Campaign No. 2021070027

SUBJECT: **Model 907 Sprinter, Model Year 2019
Software Update**

SM54.21-D-0228SG	Update software of control units (code: VS3MOGED19, acc. no.: 07 972 76)	12.12.2022
-------------------------	---	-------------------

D54.21-A036-76

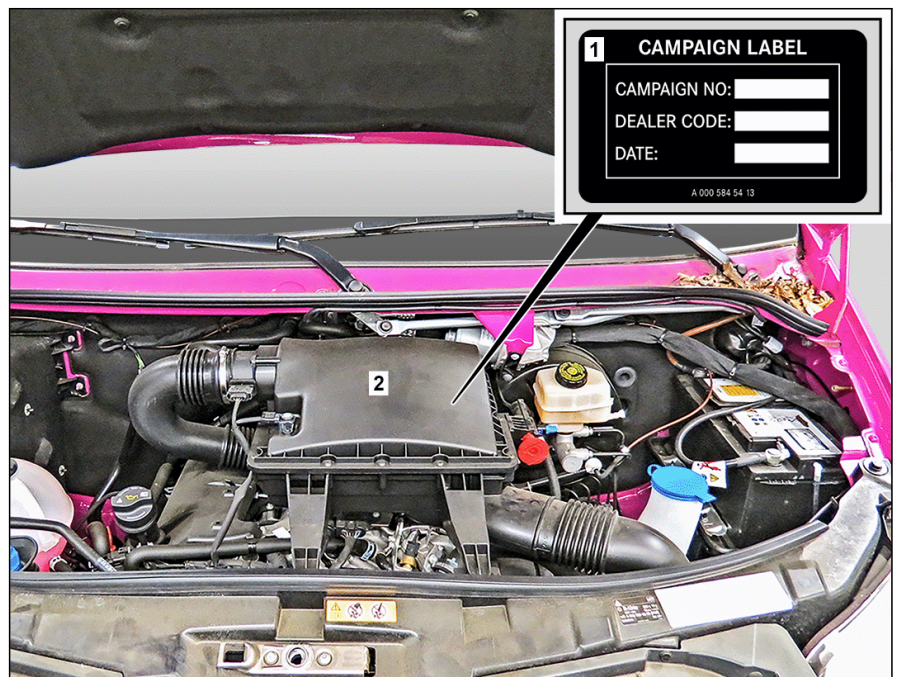
- 1 Campaign label
- 2 Air cleaner housing

8	Fill out certificate and hand over to customer.	<p>Only applies for vehicles in State of California.</p> <p>i Apply number from campaign label (1).</p>
